Product Change Notification / SYST-29FTIN870

ERRATA - dsPIC33EVXXXGM00X/10X Family Silicon Errata and Data Sheet Clarification Document Revision

Description of Change: 1) Updates silicon issue 49 (Oscillator).

dsPIC33EVXXXGM00X/10X Family Silicon Errata and Data Sheet Clarification

FIGURE 1:

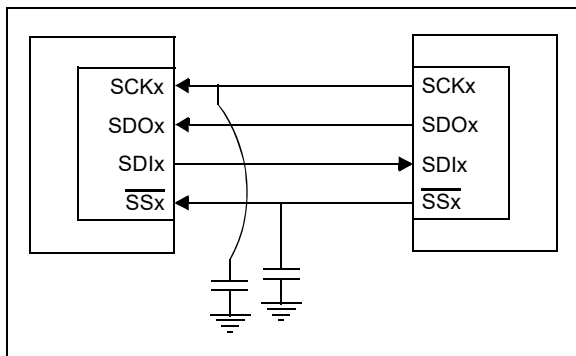
When the SPIx module is configured in SPIx Slave mode (MSTEN bit (SPIxCON1[5]) = 0), the frame slave (FRMEN bit (SPIxCON2[15]) = 1) and the SPIFSD bit (SPIxCON2[14] = 1), in Standard Buffer mode with the Clock Polarity Select bit, CKP = 0, the data are not transmitted in both 8-bit and 16-bit mode, but the data are being received correctly.

Adding a capacitance on the signal, as shown in Figure 1, will help the data to be received properly.

FIGURE 2: TIMING DIAGRAMS FOR CENTER-ALIGNED AND EDGE-ALIGNED MODES

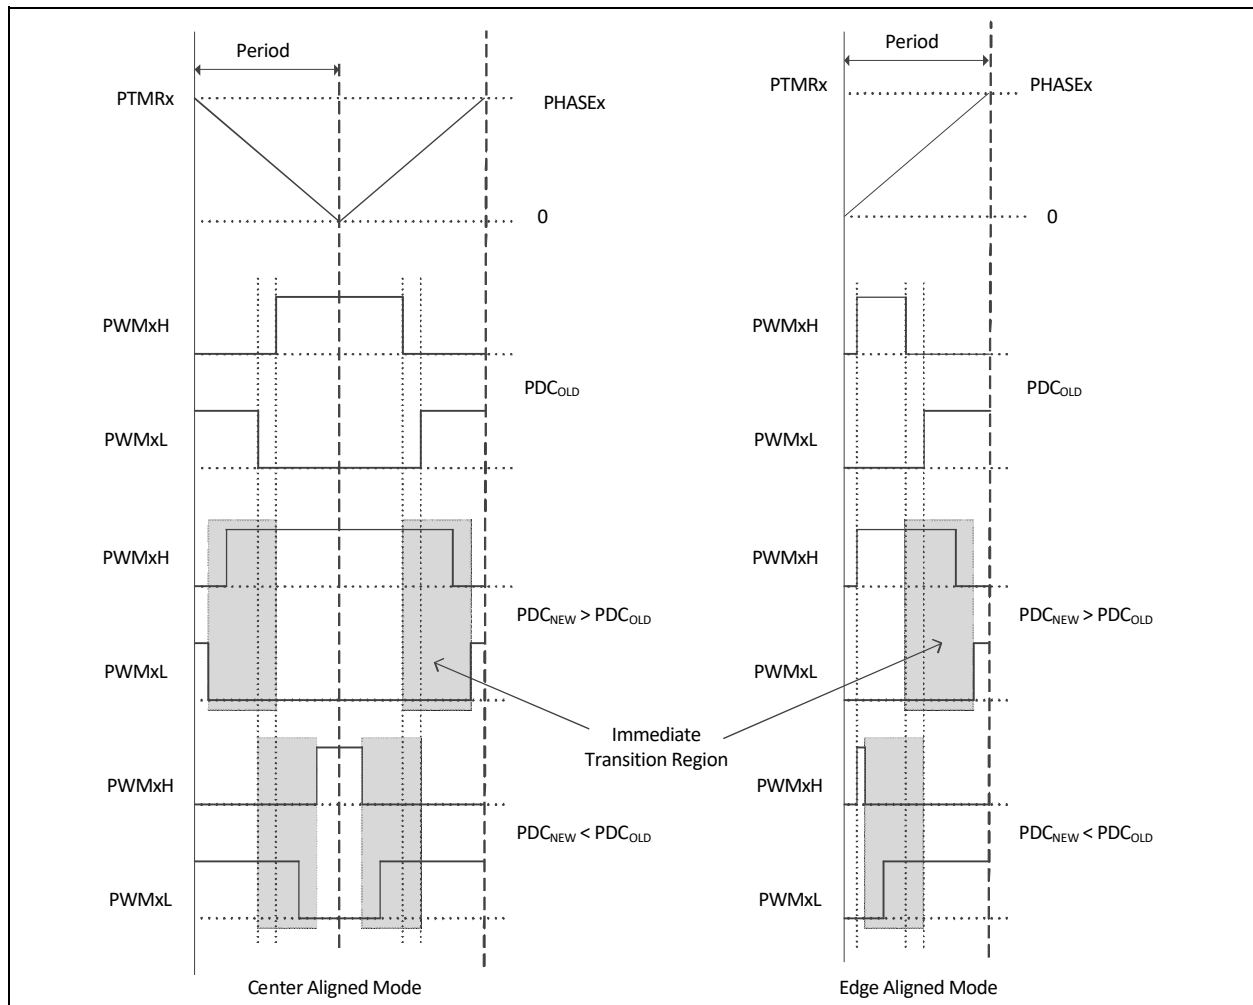
The PWM generator may not assert dead time on the edges of transitions. This has been observed when all of the following conditions are present:

- The PWM generator is configured to operate in Complementary mode with Independent Time Base (ITB) or master time base;
- Immediate update is enabled; and
- The value in the PDCx register is updated in such a manner that the PWMxH and PWMxL outputs make an immediate transition.

In [Figure 2](#), if the duty cycle write occurred in the shaded box, then PWMxH and PWMxL will make an immediate transition without dead time.

However, in most applications, the duty cycle update timing can be controlled using the TRIGx trigger or Special Event Trigger, such that the above mentioned conditions are avoided altogether.

FIGURE 3: ILLUSTRATION OF 1 TOSC GLITCH WHEN PWM OVERRIDE IS TURNED OFF

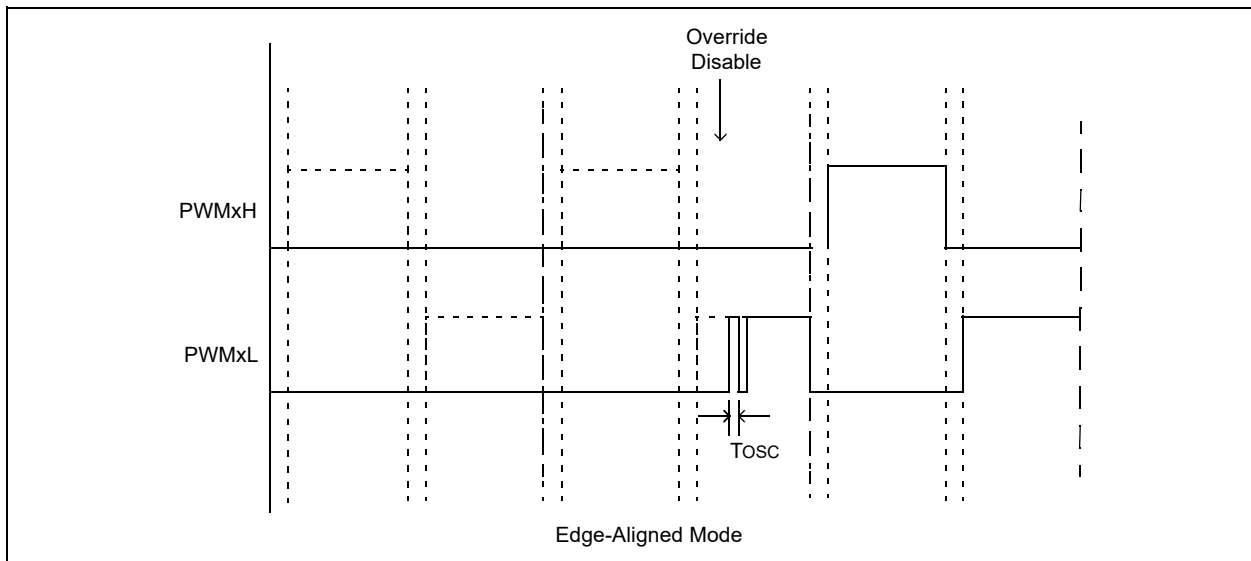
In Complementary mode after the PWM module is enabled (PTEN = 1), if the PWM override is turned off, a one TOSC glitch will be present on the rising edge of either the PWMxH or PWMxL pins, whichever occurs first, as shown in Figure 3.

The glitch will be present on PWMxH/PWMxL every time the override state is changed from override enabled to override disabled. The width of this glitch is equal to one TOSC when PCLKDIV[2:0] (PTCON2[2:0]) = 000. Increasing the PWMx input clock prescaler setting will increase the width of the glitch accordingly.

FIGURE 4:

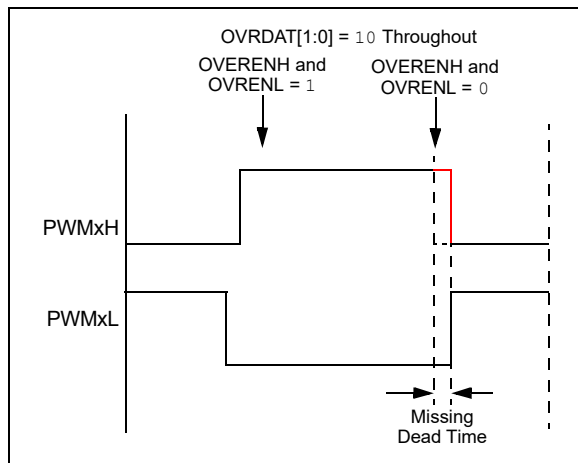
In Complementary Output mode, the expected dead time between transitions of the PWMxH and PWMxL outputs may not be asserted when the following occurs:

- Output override synchronization is configured to occur on the CPU clock boundary (IOCONx[0] = 0);
- Both PWMxH and PWMxL overrides are enabled prior to the event (OVRENH and OVRENL are both '1'), and
- Both overrides are disabled (OVRENH and OVRENL are both '0') at the instant the dead time should be asserted (Figure 4). This has been observed in both Center-Aligned and Edge-Aligned modes.

FIGURE 5:

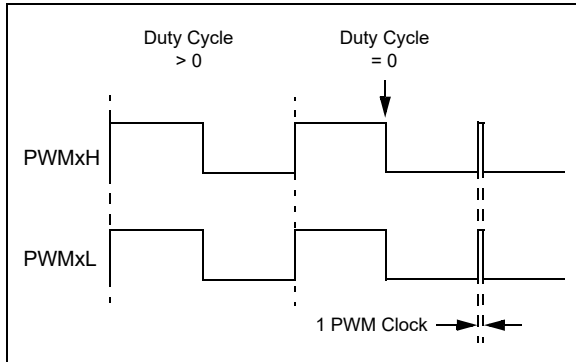
In the Redundant Output mode (IOCONx[11:10] = 10) and Push-Pull Output mode (IOCONx[11:10] = 01) with Immediate Update disabled (PWMCONx[0] = 0), when the Duty Cycle register is updated from a non-zero value to zero, a glitch pulse of a width equal to one PWM clock will appear at the next PWM period boundary, as shown in Figure 5, for the Redundant Output mode. Here, the Duty Cycle register refers to the PDCx register if PWMCONx[8] = 0 or the MDC register if PWMCONx[8] = 1.

If the application requires a zero duty cycle output, there are two possible work around methods:

1. Use the PWM override feature to override the PWM output to a low state instead of writing to the Duty Cycle register. In order to switch back to a non-zero duty cycle output, turn off the PWM override. The override-on and override-off events must be timed close to the PWM period boundary if the IOCONx register has been configured with IOCON[0] = 0 (i.e., output overrides via the OVDDAT[1:0] bits occur on the next CPU clock boundary).

2. Enable the Immediate Update (PWMCONx[0] = 1) while configuring the PWM module, i.e., before enabling the PWM module (PTCON[15] = 1). With Immediate Update enabled, writes to the Duty Cycle register can have an immediate effect on the PWM output. Hence, duty cycle write operations must be timed close to the PWM period boundary in order to avoid distortions in the PWM output.

FIGURE 6:

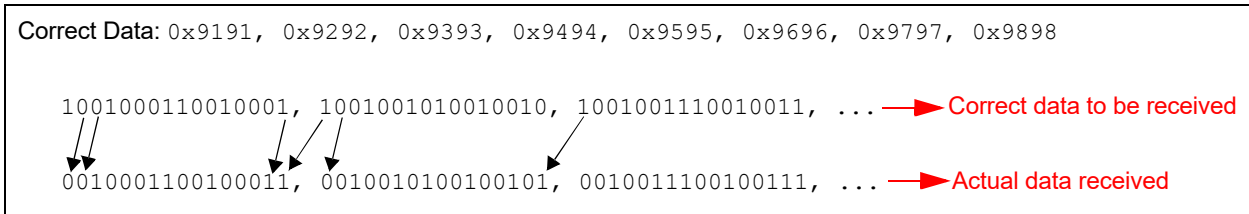
1. When the SPI is configured as master (MSTEN = 1), frame sync pulse input (SPIFSD = 1), enhanced buffer (SPIBEN = 1), CKP = 1, SMP = 1, FRMPOL = 1, FRMDLY = 1.
2. When the SPI is configured as master (MSTEN = 1), frame sync pulse input (SPIFSD = 1), enhanced buffer (SPIBEN = 1), CKP = 1, SMP = 1, FRMPOL = 0, FRMDLY = 0.

For example, the correct data that should be received are 0x9191, 0x9292, 0x9393, 0x9494, 0x9595, 0x9696, 0x9797, 0x9898, but the actual data received are 0x2323, 0x2525, 0x2727, 0x2929, 0x2B2B, 0x2D2D, 0x2F2F, 0x3130 (Figure 6).

FIGURE 7: SIMPLIFIED BEHAVIOR

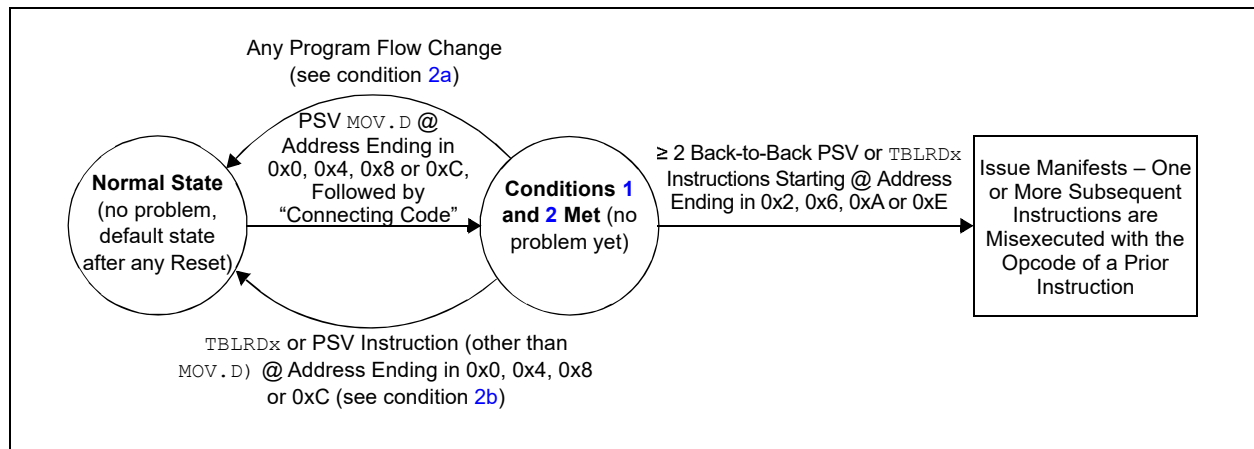
3. ≥ 2 back-to-back PSV or <code>TBLRDx</code> instructions are executed (following the code of condition 2), where the first of the back-to-back instructions is located at an address ending in 0x2, 0x6, 0xA or 0xE.

[Figure 7](#) provides an example of the effective behavior.

1. All instances of PSV `MOV.D` can be replaced with two PSV `MOV` instructions instead. Non-PSV `MOV.D` instructions acting on RAM/SFRs do not need to be modified; or
2. If not already present, a program flow change instruction (such as `BRA $+2`) can be inserted above back-to-back data Flash read sequences; or
3. Back-to-back data Flash read instruction sequences can be broken up by inserting a non-Flash read instruction (such as a `NOP`), in between the Flash read instructions; or
4. The alignment of the code can be shifted to avoid the required opcode location addresses.
